APPENDIX C

Appendix 1 – Consultation Flyer and business questionnaire

Rotherhithe movement plan

Section 15. Redriff Road (between Surrey Quays Road to Brunswick Quay)

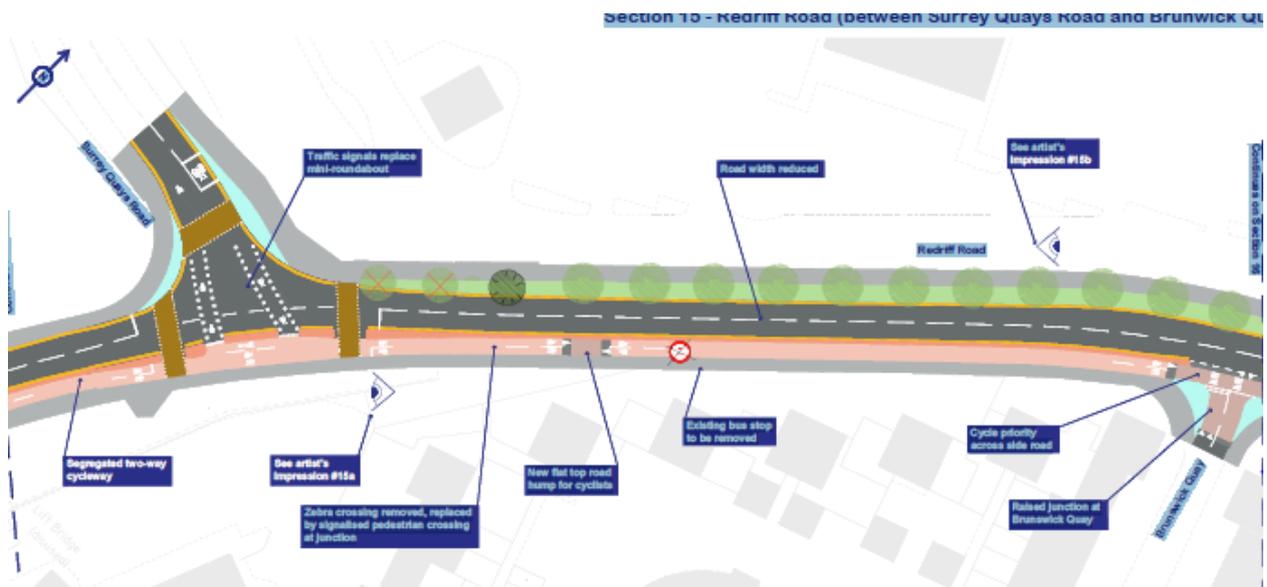
Clean and tidy	
Comments and or suggestions	Response
It will be good to remove the mini-roundabout as drivers mostly go straight over it anyway. It should reduce speeds. Good to remove the bus stop as it just causes delays for other traffic plus nuisance for residents with noise and rubbish thrown over fences by bus users.	
<p>1. Traffic signals will significantly slow down local buses in the area, which are already very slow and it takes a long while to get to the nearest tube/overground stations. This adds a lot to overall commute time.</p> <p>2. Rotherhithe Street is very narrow and it's really struggling with 2 way traffic at peak times. A cycle track will only make the situation worse.</p> <p>3. The increased number of cyclists in the area will make it less safe for walking, especially for children and parents with a buggy, it will also increase the amount of garbage on the streets and will likely lead to the increased crime rate too.</p>	It is not considered likely that the introduction of a cycle route will lead to a deterioration in the cleanliness or tidiness of the area

Crossing roads is easy and safe	
Comments and or suggestions	Response
Good to see better crossings for pedestrians	
Looks much safer for cyclists and pedestrians	
<p>The placement of the Zebra crossing matches the path from Brunswick Quay and the pedestrian entrance to the cinema. It should be kept where it is. People will cross here anyway rather than needlessly walking to your proposed new crossing.</p> <p>There is also not enough traffic or footfall on this area to warrant a signalled pedestrian crossing</p>	<p>The new crossing point is x metres from the existing crossing and will cater for those pedestrians heading towards Surrey Quays Road. The entrance into this site will no longer exist once this area is developed. So this design future proofs works when developments take place</p> <p>A zebra crossing so close to a signal junction</p>

<p>here. The zebra crossing works just fine.</p> <p>I also strongly oppose the removal of the mini roundabout. This is not a busy junction and traffic signals will just cause delays. The roundabout works extremely well right now. You seem obsessed with signals throughout all the recent plans.</p> <p>I also strongly oppose the kerb on the segregated cycleway. This will make crossing the road with a pram very difficult.</p> <p>I personally do not use this bus stop, but why is it removed? Where do brunswick quay residents get their bus?</p> <p>I also strongly oppose the kerb on the segregated cycleway. This will make crossing the road with a pram very difficult.</p>	<p>would cause confusion and as a result would be unsafe</p> <p>New crossing are proposed along the route to allow pedestrians to cross Redriff Road and Salter Road</p>
<ol style="list-style-type: none"> 1. Traffic signals will significantly slow down local buses in the area, which are already very slow and it takes a long while to get to the nearest tube/overground stations. This adds a lot to overall commute time. 2. Rotherhithe Street is very narrow and it's really struggling with 2 way traffic at peak times. A cycle track will only make the situation worse. 3. The increased number of cyclists in the area will make it less safe for walking, especially for children and parents with a buggy, it will also increase the amount of garbage on the streets and will likely lead to the increased crime rate too. 	<p>There is no reason why a cycleway should make the road less safe for pedestrians. The road width is generally being reduced, which will slow vehicle speeds and thereby lower the risk to pedestrians. In addition the proposal overall provide additional controlled crossings</p>

Easy and safe to cycle	
Comments and or suggestions	Response
<p>Principle of promoting cycling is supported. Cycle lanes generally seem quite narrow, and would ideally be wider. Concerned by side roads pulling out into two way cycle traffic. These number of roads pulling out into cycle lanes should be limited to as few as possible to minimise the chance of collisions.</p>	<p>The width of the cycleway has been dictated by available space and the desire to minimise its effects particularly with regards to trees</p>
<p>Is it possible to also place a cycle lane along Surrey Quays road? even if its not segregated, a marking on the road would be beneficial.</p>	<p>This will be investigated</p>
<p>"New flat top road hump for cyclists": Why is this necessary?</p>	<p>The flat top hump is to avoid the expense of relocating a BT cover. This will be further</p>

<p>Why remove the "left"-most trees? These are mature trees.</p>	<p>explored during detailed design.</p>
<p>The placement of the Zebra crossing matches the path from Brunswick Quay and the pedestrian entrance to the cinema. It should be kept where it is. People will cross here anyway rather than needlessly walking to your proposed new crossing.</p> <p>There is also not enough traffic or footfall on this area to warrant a signalled pedestrian crossing here. The zebra crossing works just fine.</p> <p>I also strongly oppose the removal of the mini roundabout. This is not a busy junction and traffic signals will just cause delays. The roundabout works extremely well right now. You seem obsessed with signals throughout all the recent plans.</p> <p>I also strongly oppose the kerb on the segregated cycleway. This will make crossing the road with a pram very difficult.</p> <p>I personally do not use this bus stop, but why is it removed? Where do brunswick quay residents get their bus?</p> <p>I also strongly oppose the kerb on the segregated cycleway. This will make crossing the road with a pram very difficult.</p>	<p>New crossings have been proposed at regular intervals to allow pedestrians to cross Redriff Road and Salter Road</p>

I oppose the changes because it means the loss of a significant green verge and many trees. I know the plan notes that there will be a net gain in trees, but these will be in different locations to those that will be removed. This will change the quality of the street and walking environment. More trees, planting and landscaping should be provided to mitigate the proposed loss, not elsewhere but in the same locations and proximity to the loss.

<p>only concern is lights replacing roundabout which is fine during peak times but seems unnecessary at all other times (next junctions with lights very close by). will pedestrian crossing be at request only?</p>	
<p>There does not need to be more traffic lights added anywhere along this street, the current zebra crossings work well and avoid unnecessary traffic!</p>	
<p>it's not a very busy road so not sure a traffic signal is needed? Will only cause more traffic / cars standing still therefore more pollution.</p>	
<p>The amount of traffic signals seems excessive. Stationary gas vehicles will lead to worse air quality</p>	
<p>Disagree with the introduction of traffic signals. Unnecessary and will slow down and interrupt movement.</p> <p>Disagree with tree removal.</p>	
<p>Additional set of traffic lights unnecessary</p>	
<p>Mini-roundabout would be better than traffic lights, as traffic coming through this junction varies dramatically and most traffic is left-turning. I oppose the removal of the bus stop.</p>

<p>I oppose bus stop removal. I also oppose removal of mini roundabout as this will lead to increased travel times and frustration, given the number of traffic lights in the plan and in an area of too few cyclists.</p> <p>I oppose cycle priority across side road at Brunswick Quay.</p>	
<p>Strongly opposing the removal of the mini roundabout. Adding traffic lights here does not make sense and will create more pollution. This is a low traffic area, traffic lights will make cars and motorbikes wait for no reason. Cycling traffic here is also non-existent so this will be a waste of money.</p>	
<p>Traffic signals will cause additional delays in traffic movement for no good reason.</p> <p>No Bridge in Rotherhithe street - no need for a cycle route.</p> <p>Almost no cyclists using route now, this will not change. Cycle lane not required.</p>	
<p>The roundabout works perfectly Traffic lights mean more congestion</p>

The verge is slightly narrowed at this point the daffodils look like they are close to the kerb. New daffodils will be replanted

At the next design stage we will continue this and investigate opportunities to plant additional trees

The provision of traffic signals allows us to provide crossing across each arm of the junction. The demand would be dependant on pedestrian use.

Concern over the loss of the bus stop

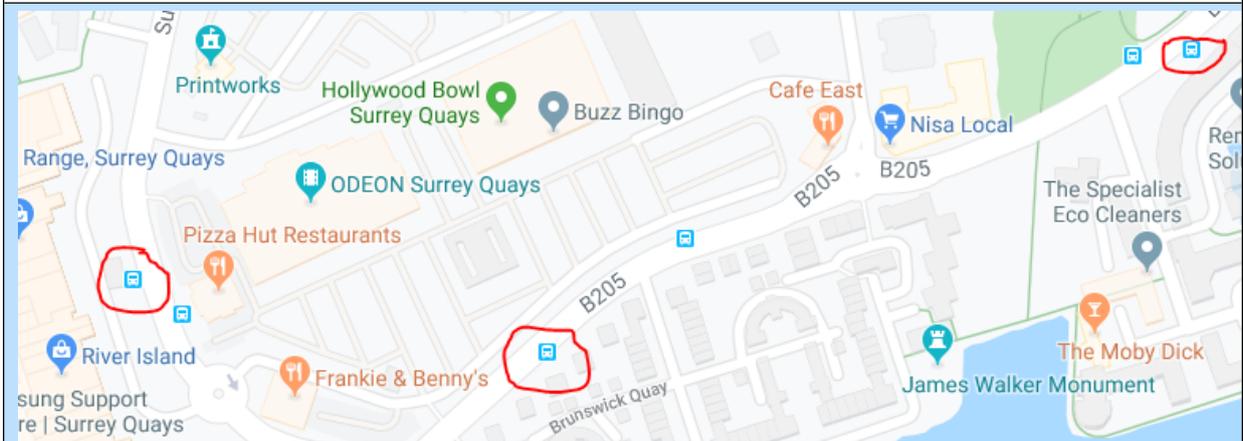
I hope that the bus stop removal will be replaced with another bus stop close by and also that the cyclists will be policed - my experience is that they mount the pavement and are aggressive and will not stop at traffic lights

I oppose bus stop removal. I also oppose removal of mini roundabout as this will lead to increased travel times and frustration, given the number of traffic lights in the plan and in an area of too few cyclists.

<p>Supporting the removal of the bus stop</p>	
<p>It will be good to remove the mini-roundabout as drivers mostly go straight over it anyway. It should reduce speeds. Good to remove the bus stop as it just causes delays for other traffic plus nuisance for residents with noise and rubbish thrown over fences by bus users.</p>	
<p>I support the swap of the mini roundabout for traffic signals as this mini roundabout is frequently ignored and I have been overtaken by other cars on this roundabout when I have been going around it and they have ignored it.</p> <p>I do not think there is a need for a cycle lane at all. This is not a busy road and is nice and wide and sufficient for all the users.</p> <p>The bus stop is seldom used and is probably surplus to requirement.</p> <p>I use the zebra crossing a lot. Is it necessary to switch it?</p>	
<p>Effects on buses</p>

To provide a segregated cycle route, bus stops are designed to be on the main carriageway with the cycleway behind the bus stop. At this location this has not been possible, as we wanted to minimise the effect on the tress on the opposite side of the road.

Section 17. Redriff Road (between Omega Gate to Ropemaker Road)

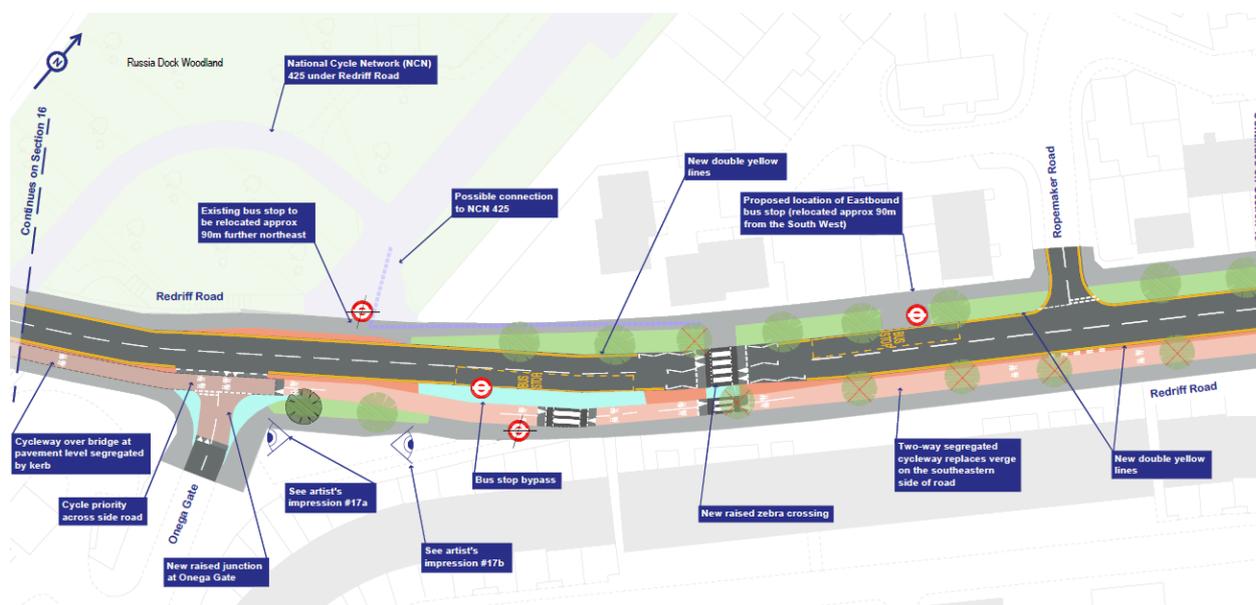
We suggest the addition of a Parallel Crossing (A Zebra that can be used by both those on foot and bicycle) at the location of the moved bus stop. This would provide a useful link into the existing National Cycle Route 425. If this is deemed too close to the Zebra crossing then this crossing should be upgraded to a Parallel Crossing and the short section of the path leading to it should be marked as a shared path for people on bicycles and people on foot.

Do not agree with traffic calming/reduction and cycle lanes	
Comments and or suggestions	Response
<p>Meaningless cycle lane in a single street road</p> <p>No need for a separated two way cycle track (and I am a cyclist and use the road every day). The road is already safe with very limited traffic and speed is limited at 20mph. You would better ensure the speed limit is respected.</p> <p>DO NOT CUT TREES or if you do plant more than you cut !</p> <p>No need to lose grass verges and trees for cyclists' safety. Instead, this is the perfect place for a speed camera, given that this is the stretch of road that people like to speed</p>	<p>The provision of safer cycling facilities is a priority for the Council. This proposal allows us to link existing and proposed cycle routes. These proposals will give people the opportunity to cycle local journeys as well journeys further afield</p>

Section 18. Redriff Road (between Norway Gate and Quietway 14 connection)

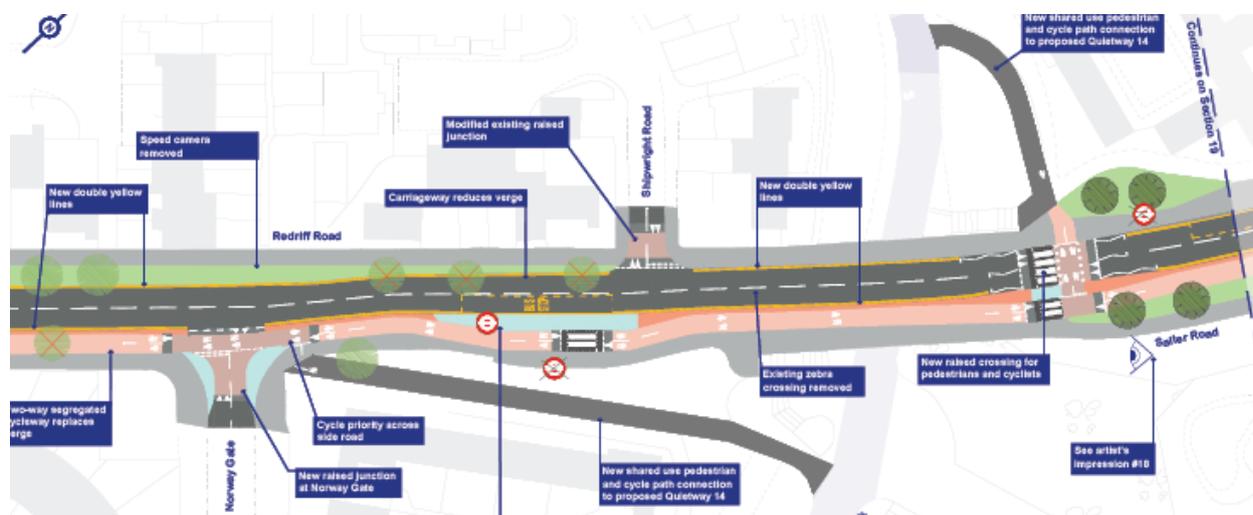
<p>traffic calming measures. A lot of traffic on this road ignores the 20mph speed limit. Cars overtaking the frequent bus services on this route have the potential to reduce the road safety of this section.</p>	<p>Southwark and London. It will not reduce traffic flow</p>
<p>Bus lay-bys are good at keeping the flow of traffic going in the area.</p>	
<p>Oppose the removal of bus lay-bys, these ease the flow of traffic and most drivers let the bus out when it needs to pull out.</p>	
<p>Strongly oppose the removal of mature trees.</p>	
<p>Please refer to previous comments which equally apply. (Removal of bus lay bys will mean that traffic will be stopped as there will be inadequate room for passing. This will cause traffic delays. Cycle lane and width restrictions not required as no one will use it - there will not be a Rotherhithe Bridge. Don't forget that the road speed in this area is already restricted to 20 mph.)</p>

<p>I am concerned at the removal of the bus lay bus and the effect this will have on the movement of traffic in this and the proposal generally. In an ideal world i would have no issue but as a cyclist I recognise that frustrated drivers can be dangerous drivers.</p>	
<p>Taking away bus lay bys and loss of grass verges is madness , the grass verges help to give the area character</p>	
<p>There should be no reduction in motor vehicle carriageway width as a result of introducing a cycle track. There should be no loss of grass verges.</p>

Section 19. Salter Road \ Rotherhithe Street

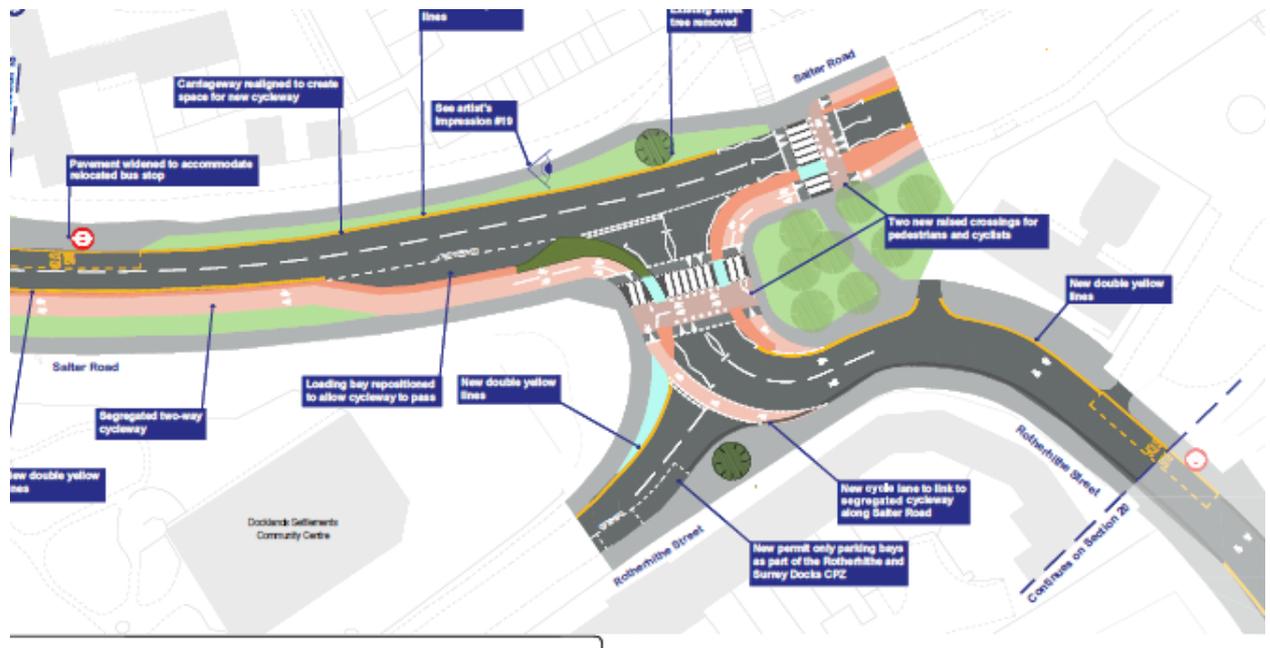
Good positioning of the loading bay. I don't agree with making cyclists turn the corner to go down

the side street before crossing and turning back onto the main road. It will slow down cyclists and discourage them from using the cycleway. The cyclists should be given right of way over the junction.

I support, but I would rather cyclists were able to carry on straight onto Salter road as they currently are

The wide corner radius for motor traffic turning from Rotherhithe Street (south) onto Salter road means traffic may not be going slow enough to spot cycles coming from Rotherhithe Street (north) to Salter Road, which would have priority.

Section 20. Rotherhithe Street (Bryan Road to Durand's Wharf)

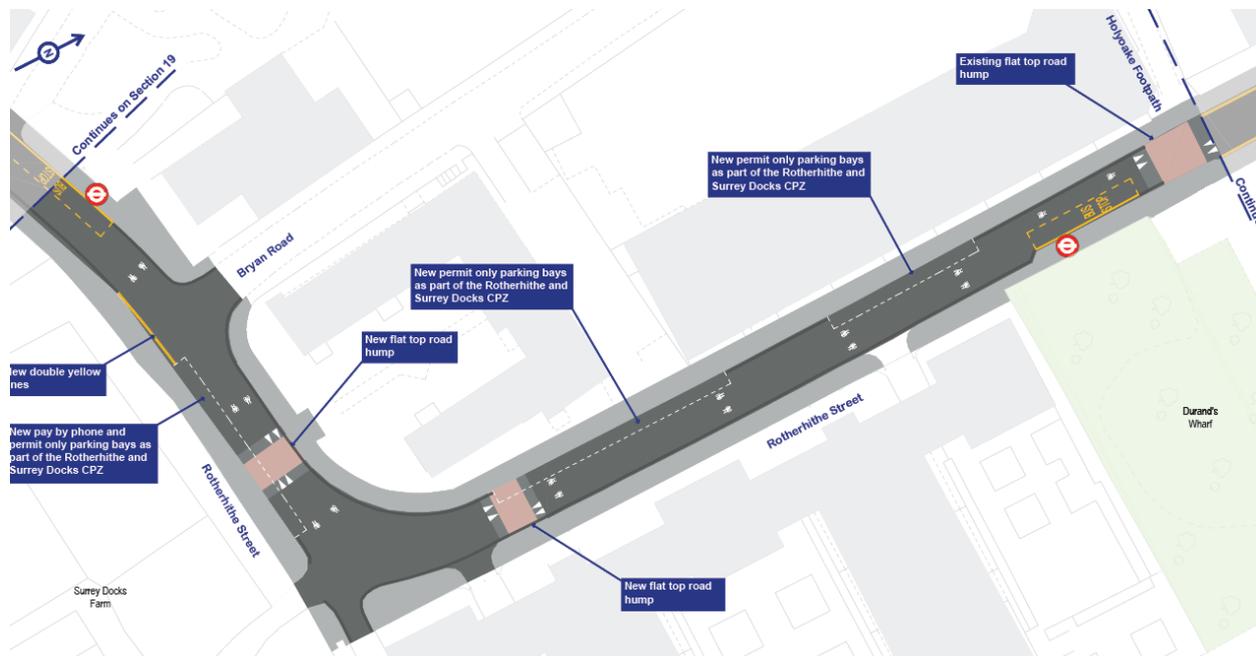
<p>This would be a very cheap way of further reducing road danger and increasing comfort when cycling.</p>	
<p>I agree that segregated cycle lanes should not be necessary for Rotherhithe Street here but, Rotherhithe Street is not sufficiently traffic-calmed to make this section an easy, accessible ride at all times for less experienced cyclists or young children. I would like to see the implementation of modal filters along Rotherhithe Street so that resident access is maintained while preventing through traffic for all modes other than buses and cycles.</p> <p>It is also worth noting that humps with a sinusoidal profile which are easier to cycle over would be preferable, even if they incorporate a flat top. Also, the humps should not be made of paving stones or any other material which becomes difficult to ride over with age and wear. Perhaps they should be made of asphalt, so that the surface is more elastic and easy to repair.</p>

<p>here will be still too many cars using the road for me to feel confident cycling here. The road needs to have closures to stop rat running.</p>	<p>Rotherhithe Street is used predominately by local traffic and is not considered to be taking rat-running traffic. So any filtered permeability would most likely not displace traffic. As Salter Road is the only alternative and is considered most likely to be a route traffic would choice to use.</p>
<p>Not sure what benefit the paint on the road will present - there should either be a traffic filter somewhere or segregated lanes for cycles.</p>	
<p>As the Rotherhithe Street doesn't have any segregated tracks it would be nice to see some traffic reduction measures which ensure through traffic takes Salter Road instead of Rotherhithe Street</p>	
<p>Painting bikes on the road does not make a safe cycle route. If people on bikes are to share the</p>

<p>highway with other vehicles there needs to be a significant amount of filtered permeability. Traffic at low speed and low volume only. This scheme does not provide that.</p>	
<p>Please consider installing a bus gate or other filtering on Rotherhithe Street just north of Acorn Walk.</p>	
<p>I agree that segregated cycle lanes should not be necessary for Rotherhithe Street here but, Rotherhithe Street is not sufficiently traffic-calmed to make this section an easy, accessible ride at all times for less experienced cyclists or young children. I would like to see the implementation of modal filters along Rotherhithe Street so that resident access is maintained while preventing through traffic for all modes other than buses and cycles.</p> <p>It is also worth noting that humps with a sinusoidal profile which are easier to cycle over would be preferable, even if they incorporate a flat top. Also, the humps should not be made of paving stones or any other material which becomes difficult to ride over with age and wear. Perhaps they should be made of asphalt, so that the surface is more elastic and easy to repair.</p>

<p>make sure road is truly low-traffic, possibly introduce filtering or a moving bollard to restrict motor vehicle flows</p>	
<p>So far this is probably the least positive section for cyclists. It's hard to make out from the proposals but it seems like there will be still be cars double parked? Then when face with the C10 coming at you, it's a little bit ominous...</p>	<p>The design of this section of Rotherhithe Street has been designed to accommodate the competing uses for this location. The design attempts to cater for, buses, cyclists on-street parking, pedestrians and local traffic.</p>
<p>Parking restrictions are a good idea. But you need segregated cycling here too.</p>	<p>There is insufficient space to accommodate segregated facilities along Rotherhithe Street, the</p>
